Subject: Meeting on Stress Analyses for Underground Piping  
In Attendance: Bethesda, P-111 + 9:00 a.m. Jan. 20, 1981

NRC-ETEC-BECHTEL  
MEETING JANUARY 20, 1981  
BETHESDA, MARYLAND

QUESTIONS FOR CONSUMERS POWER COMPANY CONCERNING  
THE DEFORMATIONS OF BURIED PIPING DUE TO  
DIFFERENTIAL SOIL SETTLEMENT AT MIDLAND PLANT UNITS 1 AND 2

MEMORANDUM FOR: F. Miraglia, Acting Chief, Licensing Branch No. 3, DL  
FROM: Darl Hood, Project Manager, Licensing Branch No. 3, DL  
SUBJECT: NOTICE OF MEETING - STRESS ANALYSES FOR UNDERGROUND  
PIPING - MIDLAND PLANT UNITS 1 & 2

8-1HBC-81

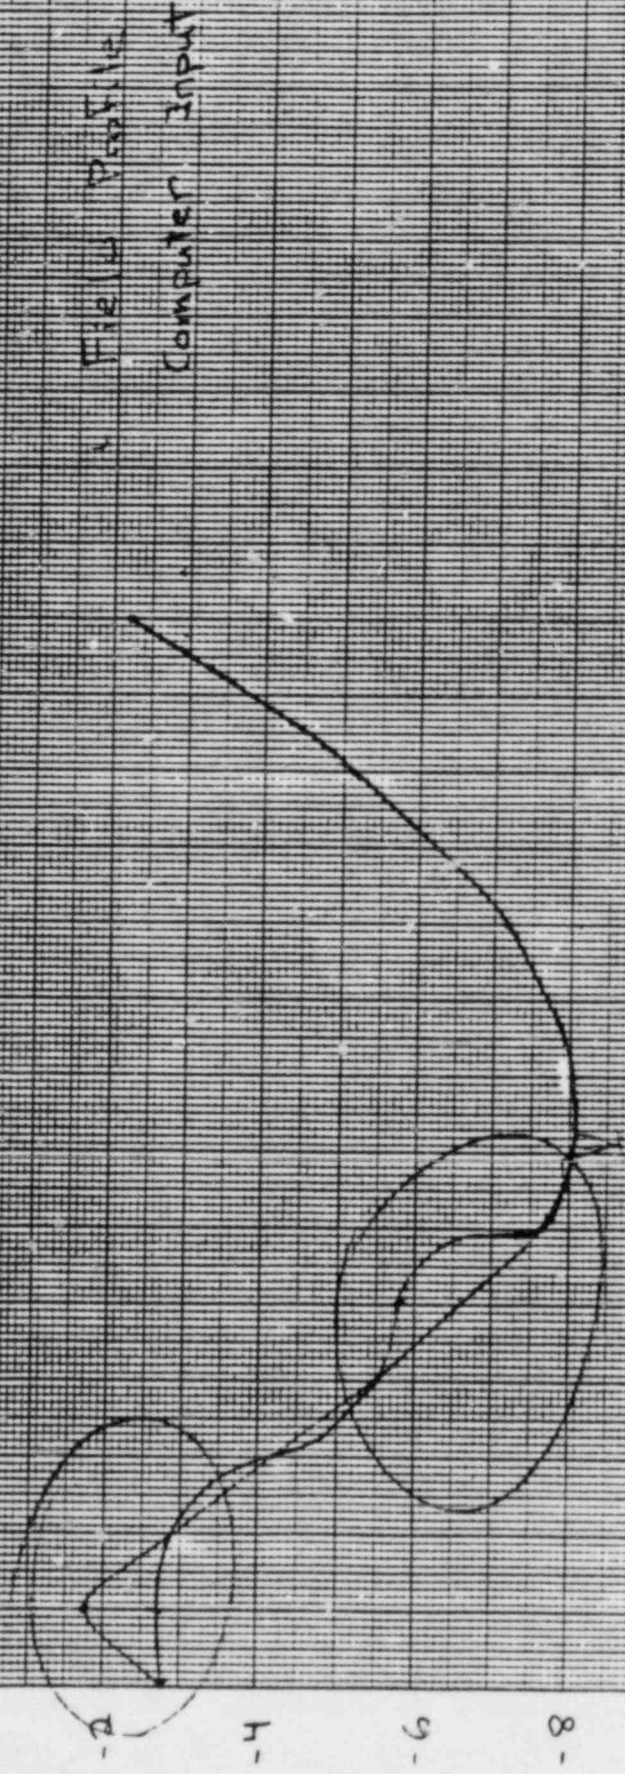
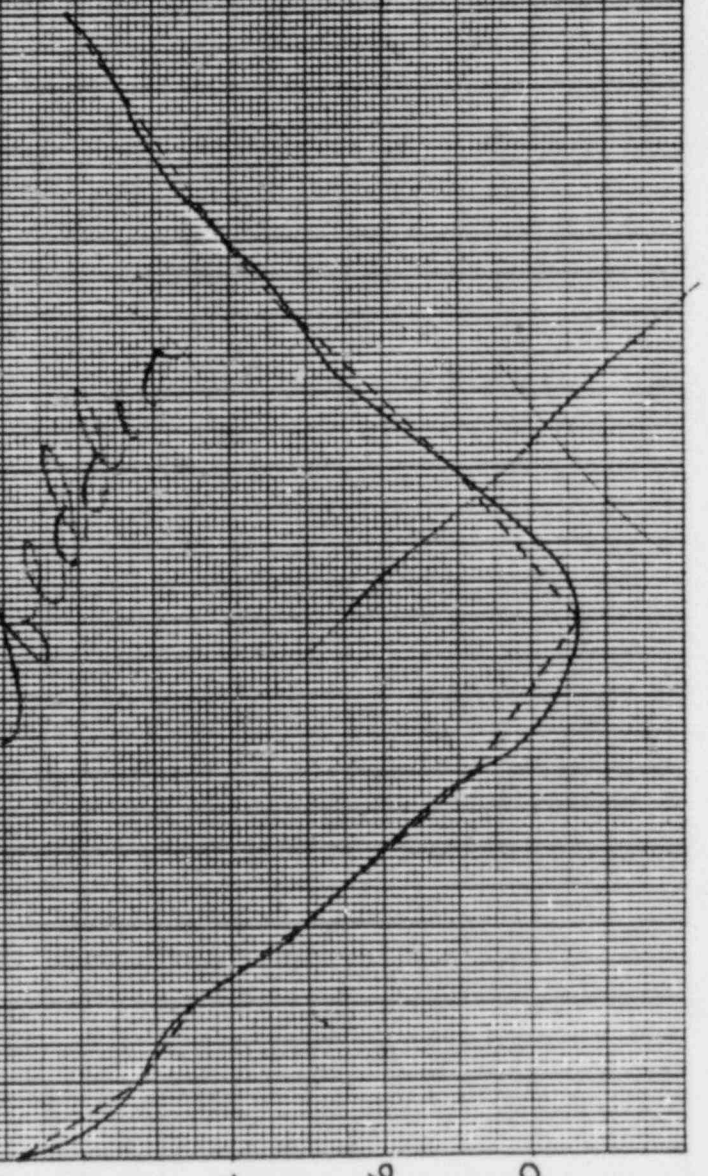
Explain rebound effect at 10" - CHBC - 27? (Request of Al Buss)

26-0450-54  
SEPT. 79 DATA.

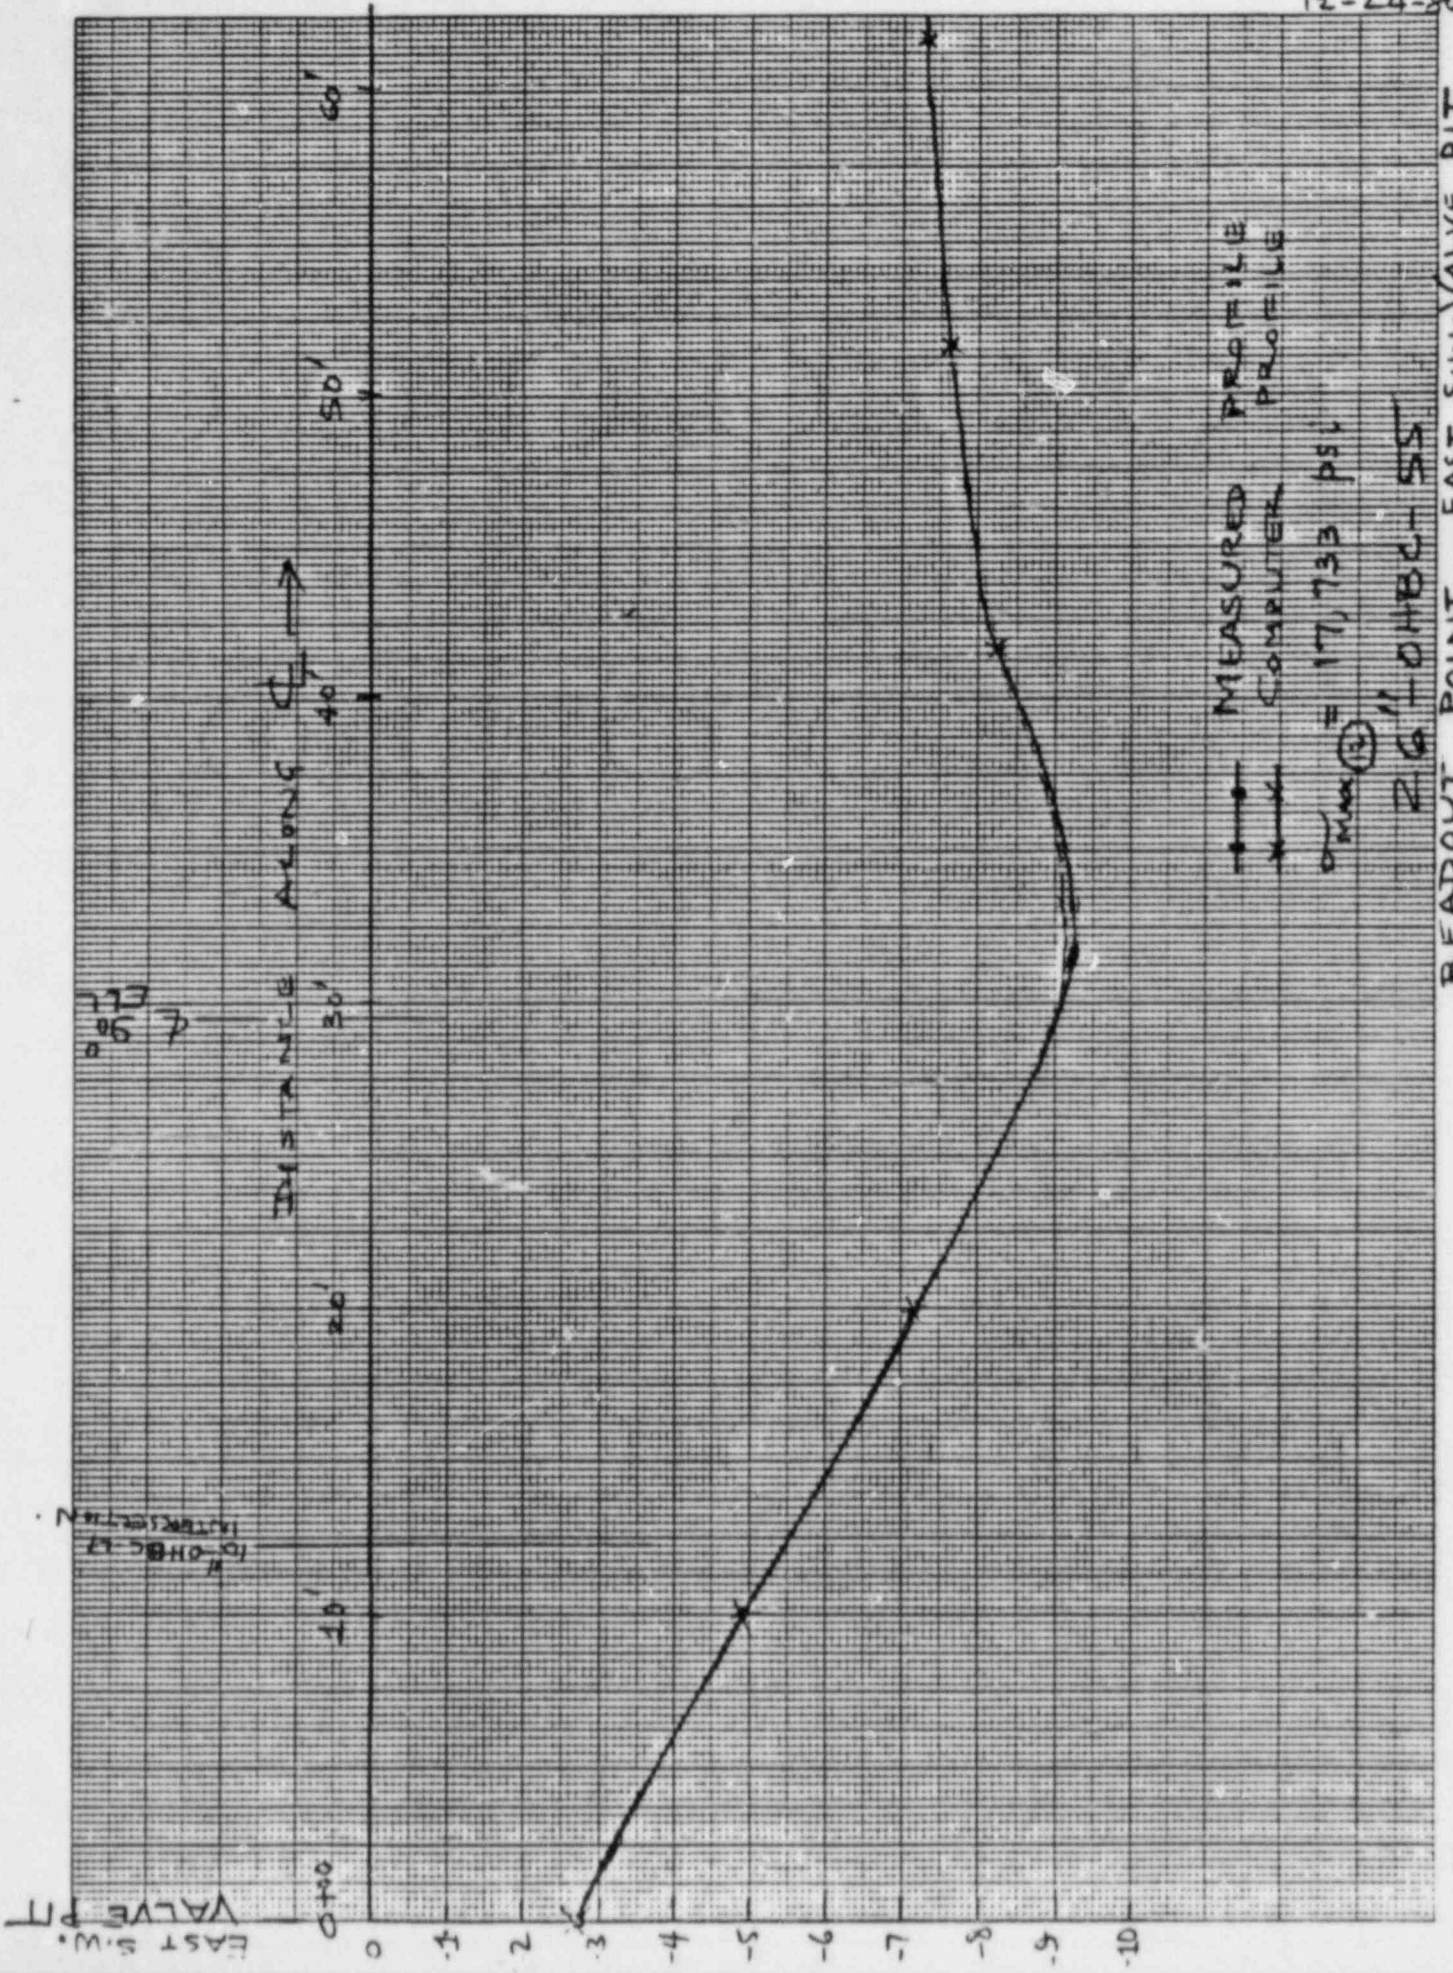
1. ETEC Telecon Questions of 1/14/81
  - a. Reason for Different Allowables
  - b. Basis for Allowables
  - c. Connection Detail 36" to 26" Service Water
  - d. Two Profiles of 26-OHBC-54
  - e. Reason for Change in Profiles Rev 2 to Rev 10
  - f. High Stress Levels
  - g. End Support Assumptions, Fixed or Hinged
